Contents

Comments

Proposed Remedy

3. change the following state machine for the primary and secondary as shown for the primary.

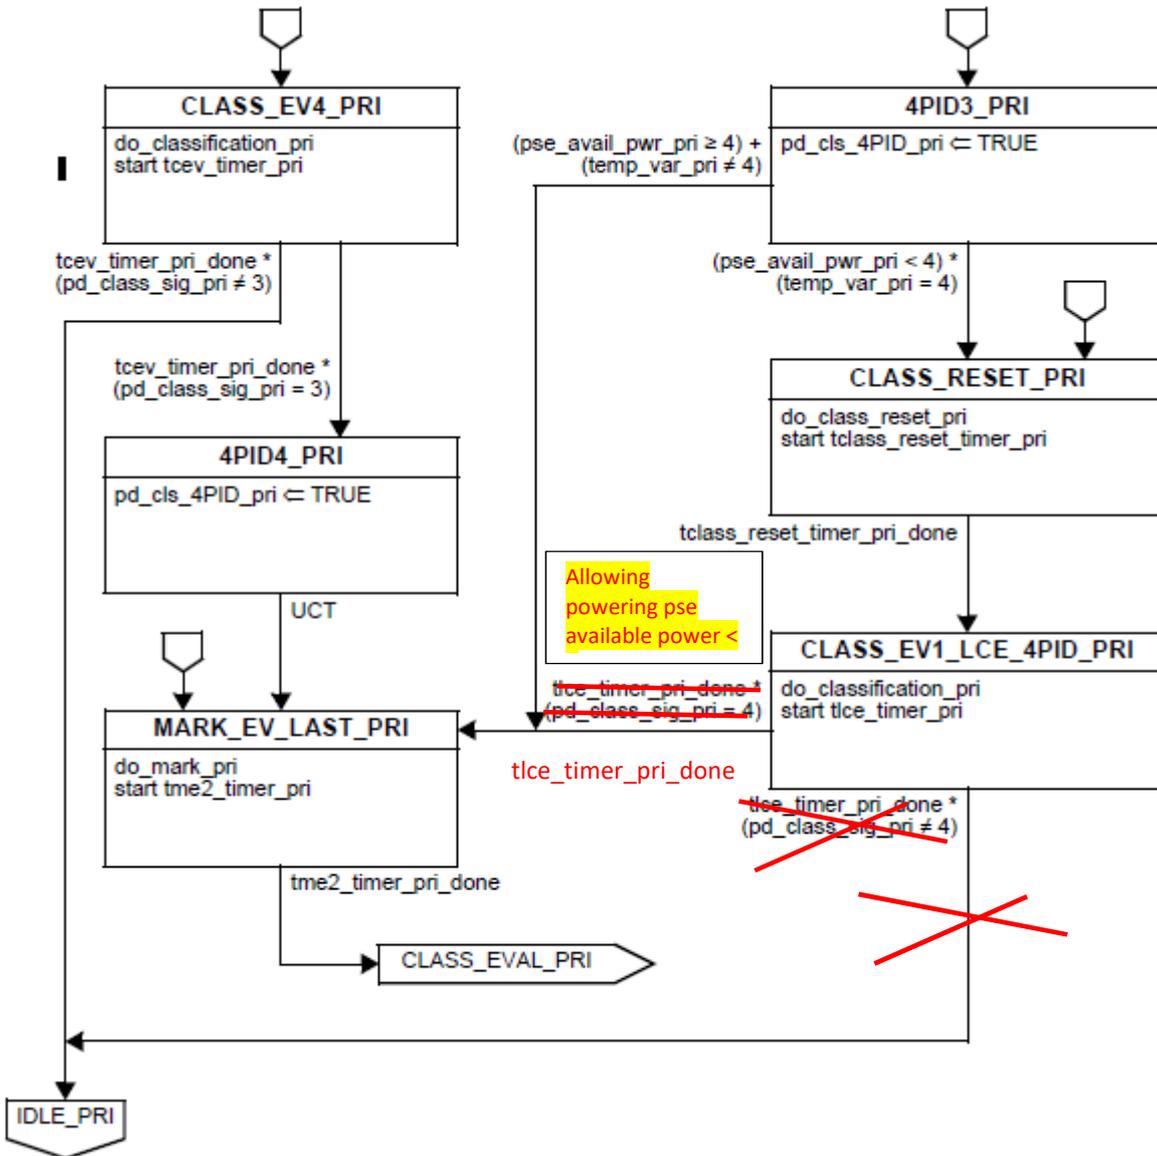
- d) This item was deleted.
- e) The intent when doing CLASS_PROBE_PRI with 3 short class events when $pse_avail_pwr_pri < 4$ was to go to class reset and then to single long class event and then power up. Now in D3.1, If option_class_probe is set, state machine will either go to IDLE_PRI or to CLASS_RESET_PRI and from CLASS_RESET_PRI eventually to IDLE_PRI instead of continuing towards MARK_EV_LAST_PRI and powering the port while allowing powering with only single long class event and not twice. This is not working. [See Annex C for details.](#)

If option_class_probe is set and pse_avail_pwr_pri<4, the state machine will either go to IDLE_PRI or to CLASS_RESET_PRI and from CLASS_RESET_PRI through CLASS_EV1_LCE_4PID_PRI eventually to IDLE_PRI instead of continuing to MARK_EV_LAST_PRI towards powering the port, which is an error (The intent was to allow powering while doing only single long class event and not twice as we had in D3.0. **Now it will not power at all regardless the route we take from CLASS_EV1_LCE_4PID_PRI.**

The solution: To flip the exits from CLASS_EV1_LCE_4PID_PRI to allow powering PDs with class 1 to 3 that matches pse_avail_pwr_pri<4 after doing CLASS_RESET_PRI.

1. **Change the exit from CLASS_EV1_LCE_4PID_PRI to MARK_EV_LAST_PRI from:**

tlce_timer_pri_done * (pd_class_sig_pri = 4) to: tlce_timer_pri_done * (pd_class_sig_pri ≠ 4)

2. **Change the exit from CLASS_EV1_LCE_4PID_PRI to IDLE_PRI from:**

tlce_timer_pri_done * (pd_class_sig_pri = 4) to: tlce_timer_pri_done * (pd_class_sig_pri = 4).

5. change the following state machine for the primary.

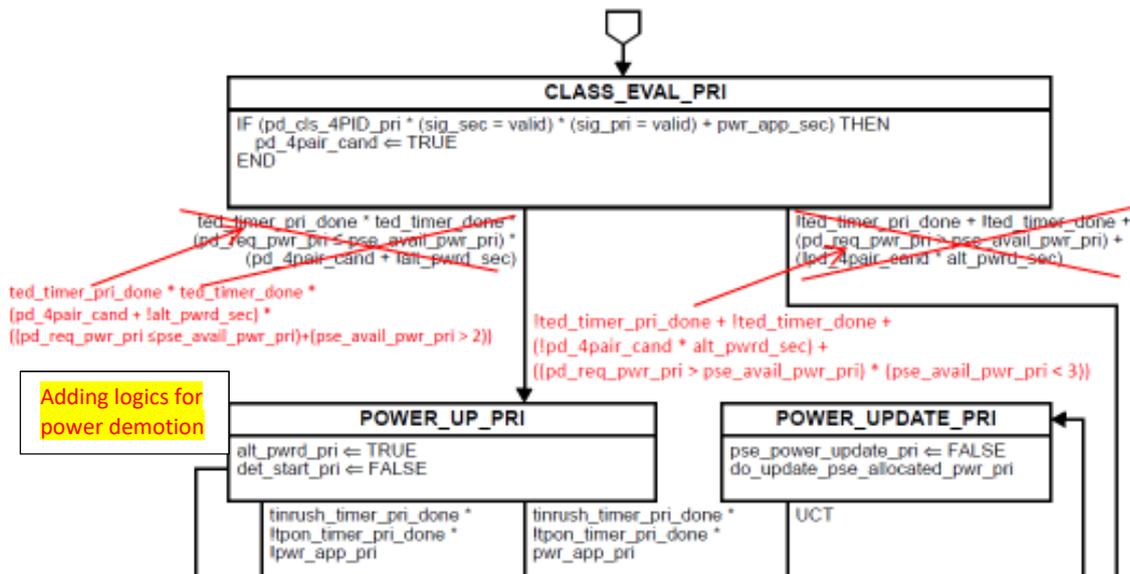
- f) Missing logic for power demotion in the exits from CLASS_EVAL_PRI (and CLASS_EVAL_PRI). [See Annex D.](#)
- g) All the above issues are the same for the secondary as well.

1. Change the exit from CLASS_EVAL_PRI to POWER_DENIGED_PRI from:

$!ted_timer_pri_done + !ted_timer_done + (pd_req_pwr_pri > pse_avail_pwr_pri) + (!pd_4pair_cand * alt_pwr_sec)$

To:

$!ted_timer_pri_done + !ted_timer_done +$
 $(!pd_4pair_cand * alt_pwr_sec) +$
 $((pd_req_pwr_pri > pse_avail_pwr_pri) * (pse_avail_pwr_pri < 3))$

2. Change the exit from CLASS_EVAL_PRI to POWER_UP_PRI from:

$ted_timer_pri_done * ted_timer_done * (pd_req_pwr_pri \leq pse_avail_pwr_pri) * (pd_4pair_cand + !alt_pwr_sec)$

To:

$ted_timer_pri_done * ted_timer_done *$
 $(pd_4pair_cand + !alt_pwr_sec) * ((pd_req_pwr_pri \leq pse_avail_pwr_pri) + (pse_avail_pwr_pri > 2))$
